FIELD SERVICE BULLETIN

FSB Number: LVCCFSB2005-35
Authors: Darwin Garcia
Date: February 16, 2005
Total No. of Pages: 2
Subject: **MPX220 No Camera Image**
Model Affected: **MPX220**
Level of Repair: 2

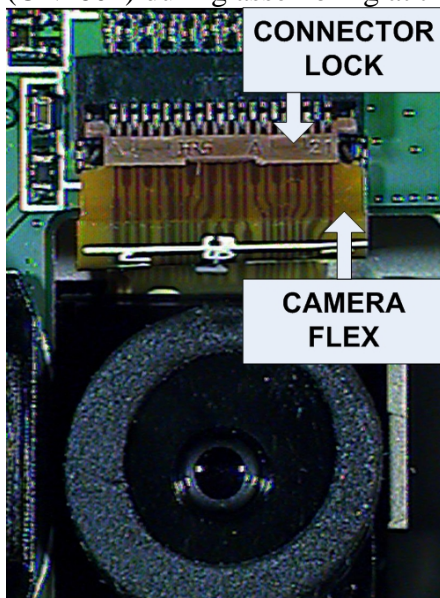
Service has detected a no camera image issue during MPX220 NPI process. When the camera application is enabled, a black image appears on preview pane.

This is due to the flex of the camera not being pressed to fixed position on jig connector (CN1601) during assembling at the factory.

The factory modified the assembly process and enhanced testing to ensure the flex of the camera is pressed to fixed position on jig connector. Also the internal quality team will perform random audits.

When servicing any MPX220 customer phones with this issue, disassemble the rear flip housing, reconnect the camera flex to fixed position on the jig connector and ensure the connector's lock is in place. Re-test the camera functionally since a defective camera could cause the same symptom.
